IN THE DRAWINGS:

ANNOTATED SHEET SHOWING CHANGES

Serial No.: 09/832,160

Docket No.: 2269-3846.2US

Fig. 6B

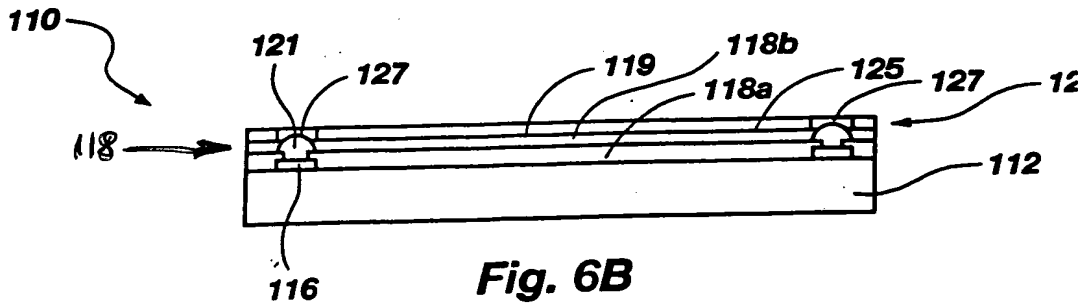
The attached sheets of drawings includes changes to Figs. 6B, 6C, and 8D. In each of Figs. 6B and 6C, reference character 118, which is mentioned in the specification, has been included with an appropriate lead line. In Fig. 6C, reference character 127a has also been replaced with reference character 127. In Fig. 8D, reference characters 218' and 222' have been replaced with reference characters 218 and 222, respectively.

Figs. 6B and 6C of the drawings have also been objected to under 37 C.F.R. § 1.84(p)(5) for failing to show reference character 118.

Appropriate corrections were made to these drawings by including reference character 118 and an appropriate lead line in each of Figs. 6B and 6C.

Fig. 8D

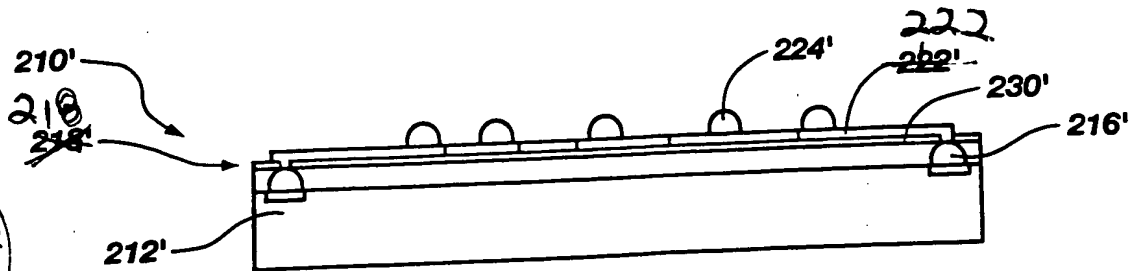
The drawings have been objected to for failing to comply with the requirements of 37 C.F.R. § 1.84(p)(4). Specifically, it has been asserted that each of Figs. 1, 1A, 6B, 6C, 8A, 8D, 9A, 10A, and 10B includes multiple reference characters that designate the same element. It has also been asserted that reference characters 18 and 118 have “been used to designate multiple different parts.” Office Action of December 18, 2003, page 2.
